UNITED STATES ENVIRONMENTAL PROTECTION AGENCY

May 4, 2010

Re: Information Request for NPDES Permit Re-issuance, NPDES Permit No: NH0001473

The New England Regional office of the United States Environmental Protection Agency (EPA or Agency) is developing a draft National Pollutant Discharge Elimination System (NPDES) Permit (No. NH0001473) for Public Service of New Hampshire's (PSNH or the Company) Schiller Station electrical generating facility in Portsmouth, New Hampshire (Schiller Station).

Figure 1: Approximate thermistor locations

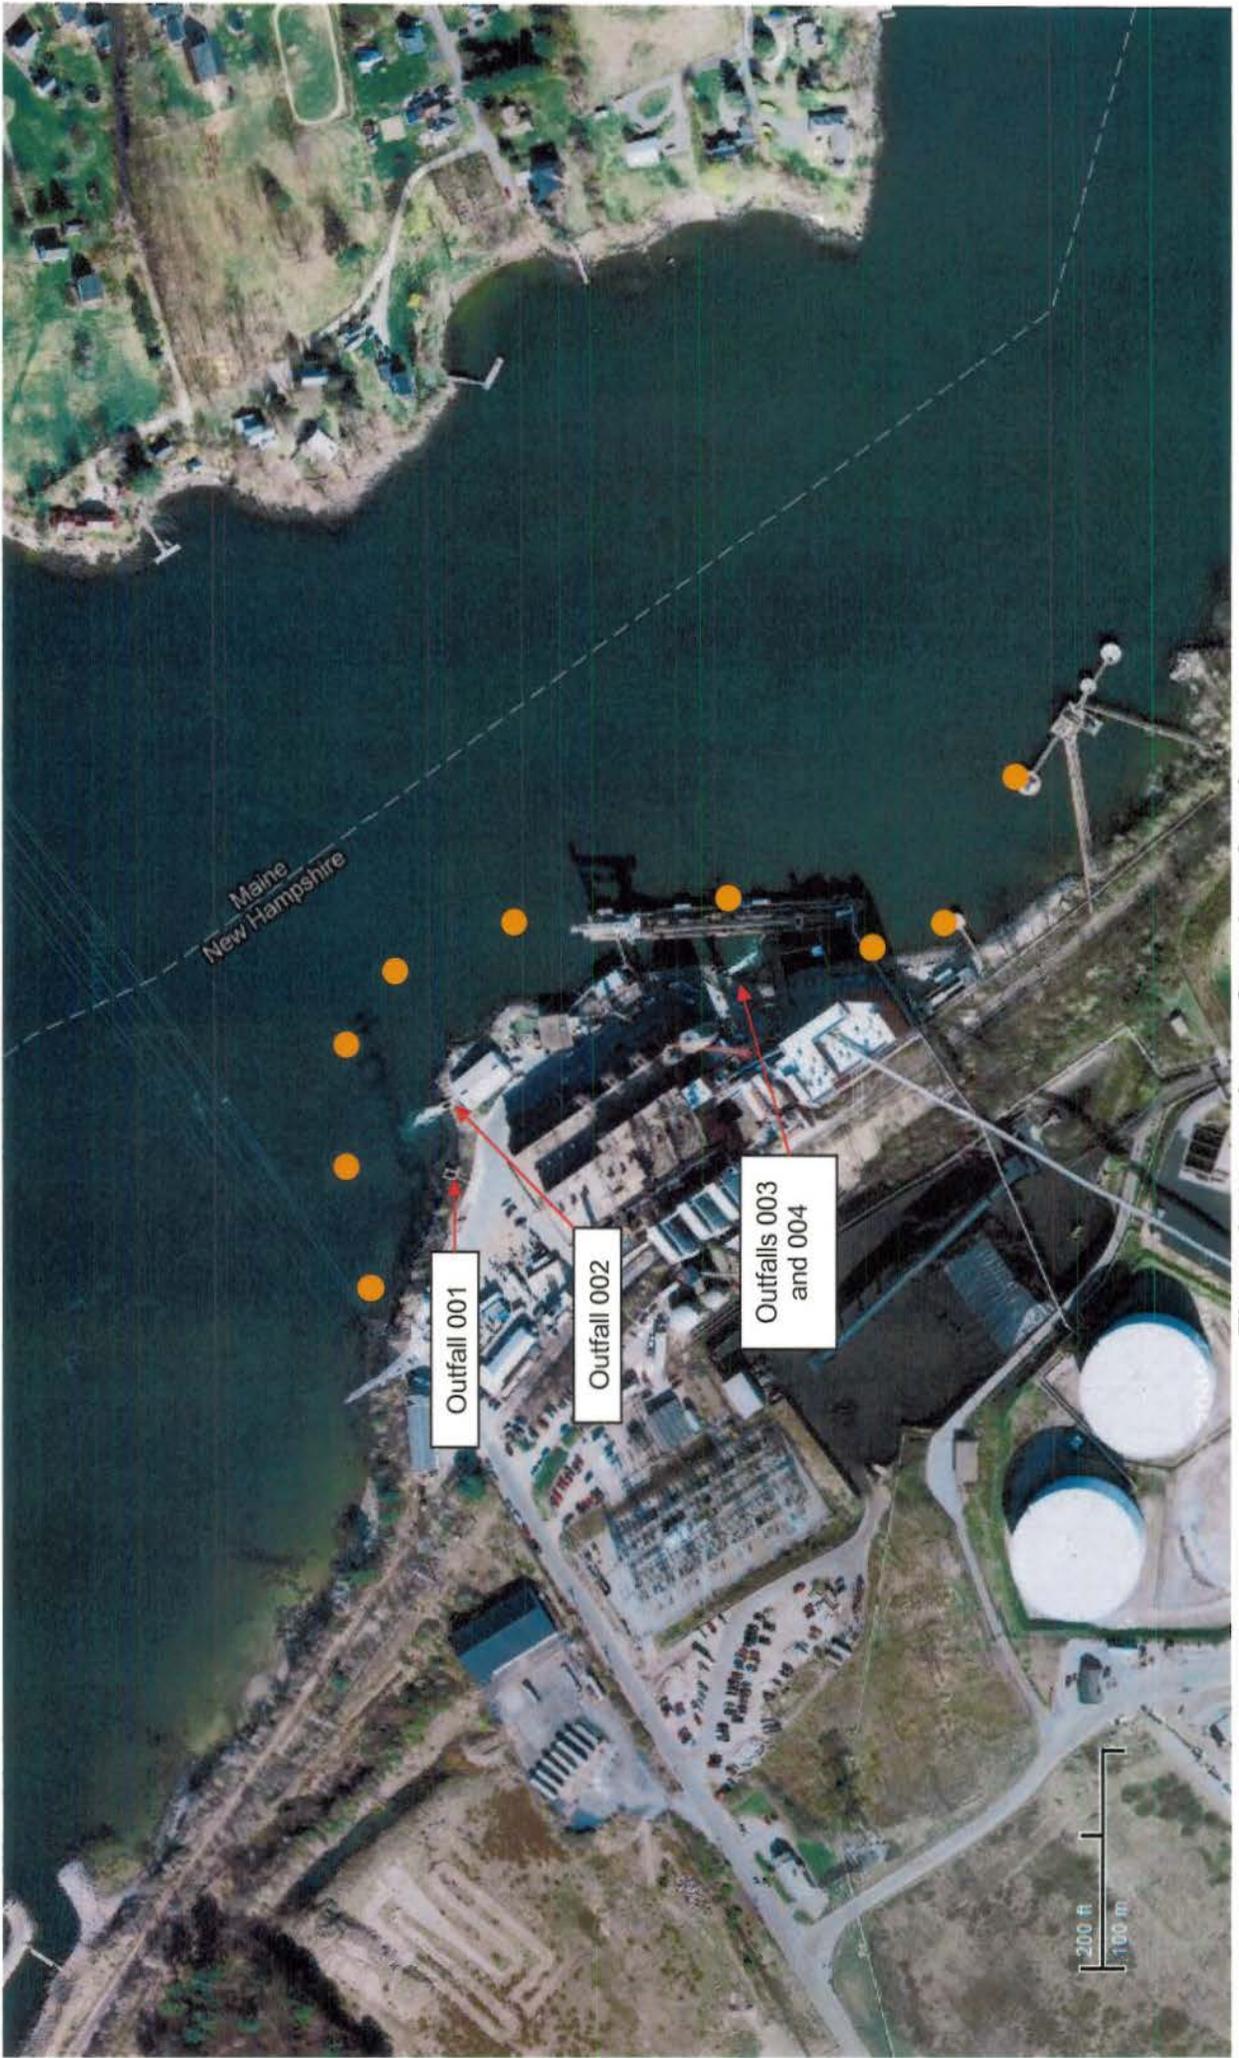
Deploy thermistors at the approximate locations shown on the attached Figures 1 through 4 and deploy thermistors in location(s) to collect ambient Piscataqua River temperature. Please identify monitoring location(s) to collect the ambient Piscataqua River temperature. The ambient monitoring location(s) must be outside of the effects of the thermal plume(s) and will be used to determine background river temperature. Therefore, ambient temperatures must be recorded at locations upstream and downstream of Schiller's discharge. Ambient temperature readings may be taken near the surface.

For water depths greater than twenty (20) feet, use three (3) thermistors per location (one approximately six (6) inches below the water surface, one approximately one (1) foot above the river floor, and one approximately midway between the other two thermistors). For water depths less than twenty (20) feet, use two (2) thermistors per location (one approximately six (6) inches below the water surface, and one approximately one (1) foot above the river floor).

Thermistors should not be floating on the water surface.
